# **Norman Gaume, P.E. (ret.)**

SUBJECT: Gila River Diversion Planning—Process and Facts

## ATTACHMENT TO APRIL 30, 2014 LETTER REPORT

### REASONS THE BOHANNON-HUSTON DRAFT FINAL PRELIMINARY ENGINEERING REPORT'S PREFERRED ALTERNATIVE IS FATALLY FLAWED AND THE COST ESTIMATE IS AN INDEFENSIBLE LOW-BALL

**Figure 1: Annual Divertable Water Supply Under CUFA--1993-2012  
 (based on ISC spreadsheet of daily diversions  
 provided February 18, 2014 in response to IPRA request)**

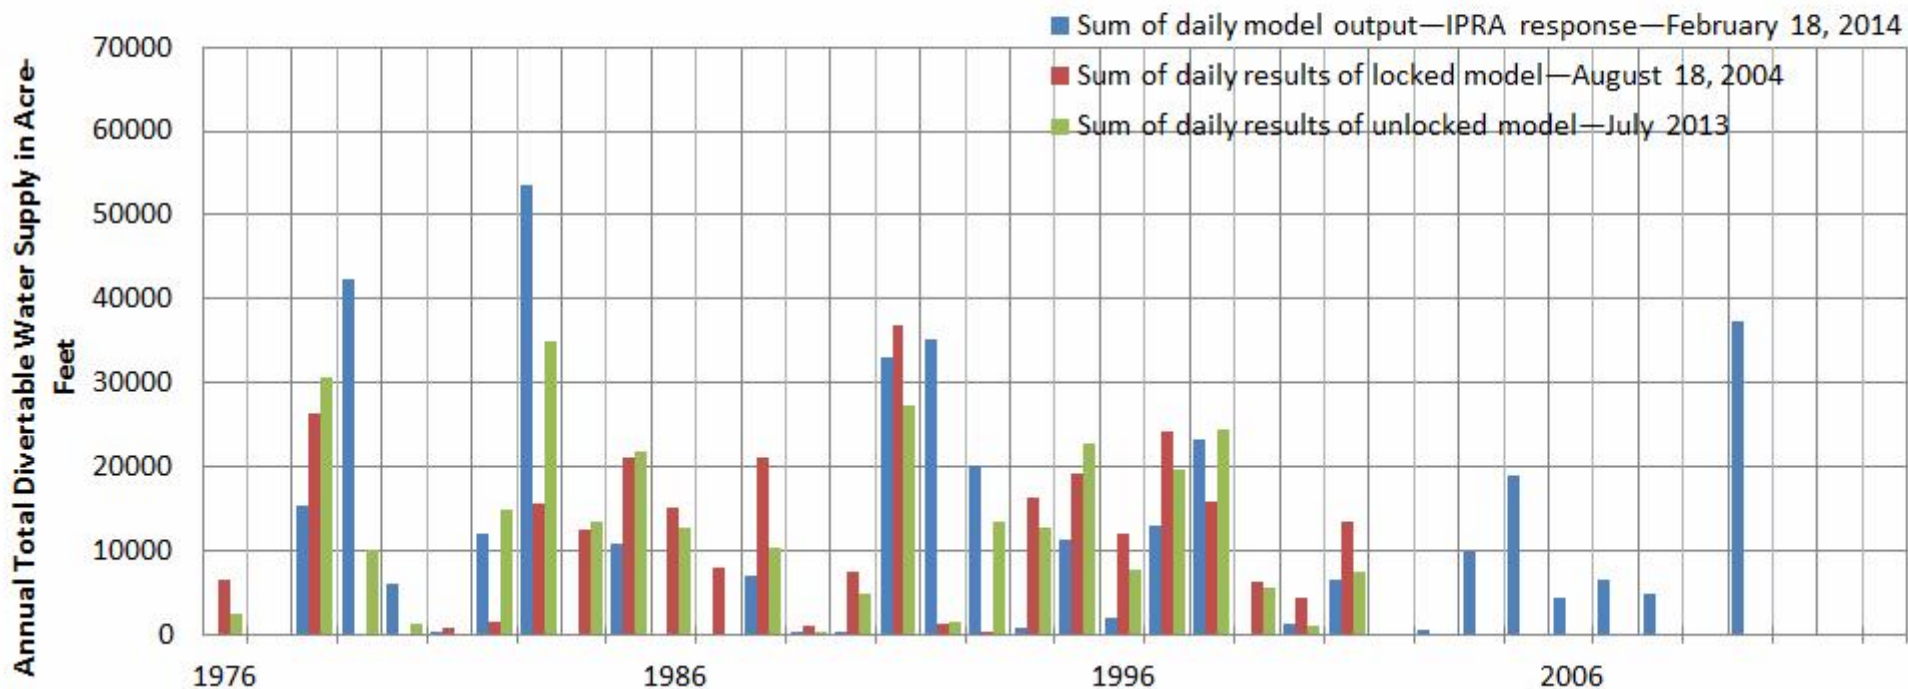
The ISC has three times since December 2013 denied my requests for a copy of its CUFA spreadsheet model.<sup>1</sup> However, the ISC determined I was entitled pursuant to my Inspection of Public Records Act (IPRA) request to receive the model results; that is, the model calculation results of the legally available water supply each day from October 1, 1936, to March 31, 2013. I used these data to prepare Figure 1, which shows the annual quantity of water available for diversion under the CUFA for the most recent 20 calendar years. The mean is only 8,000 acre-feet.

illustration I reduced the model calculations by 8%, leaving 7,400 acre-feet per year. This amount likely overestimates future legally available supply for reasons I will explain below. If half of this legally available supply were lost to evaporation and seepage from the shallow, off-channel reservoirs that the process is contemplating, the mean annual net yield over the last 20 years would be only 3,700 acre-feet per year. Figure 1 also illustrates that the legally available water supply during a critical extended low flow period from 1999 through 2003 averages only 1,600 acre-feet per year. Similarly, diversions during the low yield 10 years starting in 1999 would be only 4,900 acre-feet per year. These low water supply amounts would yield much less due to storage losses. Even though the limits to water supply illustrated by Figure 1 are crucially important to sound decision-making, the process has pretended the annual yield is 14,000 acre-feet, graphic evidence that this process is flawed and is misleading the public and decision-makers.

## Figure 2: Conflicting ISC Information Regarding Gila River Annual Divertable Water Supply 1936 through 2012

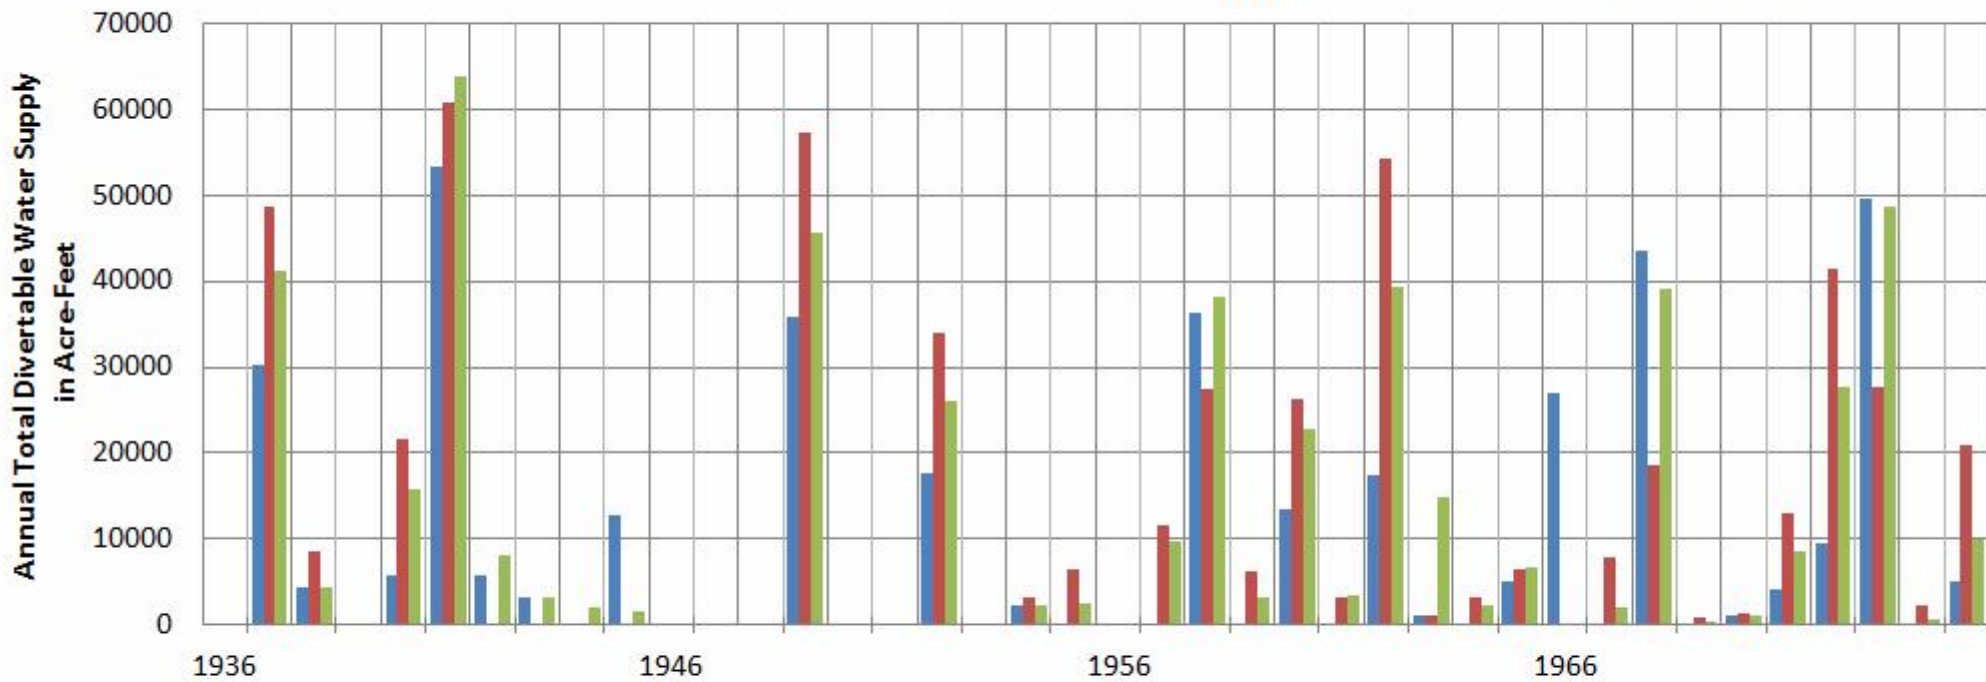
I have obtained two prior versions of the ISC CUFA model spreadsheet. I compared these model results to the model results the ISC produced to me on February 18, 2014, pursuant to my IPRA request. These three sets of model results are markedly different, as illustrated in Figure 2. Further, I have found errors in the 2013 CUFA model. These marked differences between different versions of the model is a problem. The errors and the processes' false reliance on the quantity of junior water rights as a surrogate for the legally available wet water supply mean that you, the decision-makers, are misinformed. The information informing your decision should be clear and reliable, but it currently is neither.

Why has the process kept the CUFA model a secret? The highly variable results from different versions of the secret model as illustrated in Figure 2 and the absence of any process discussion of the threshold feasibility questions of project yield and reliability of yield in conjunction with the information in Figure 1 suggest the flawed process is intended to avoid public knowledge or discussion of the certainty that the Gila River diversion project can yield only a fraction of the junior water right or the likelihood that the safe yield might be very small or even zero. Why are New Mexicans being subjected to the misleading hard sell? I urge you to direct the necessary changes to the current flawed process so that it is forthcoming and will publicly provide, for review, the ISC's best estimate of the water that the ISC calculates will flow to the water users. How does the ISC proposed to allocate the limited yield? The process has implied that all needs can be met with this project. The river will be kept wetter during dry periods. The irrigators will have a supplemental supply of stored water for use in dry times. Large amounts of water
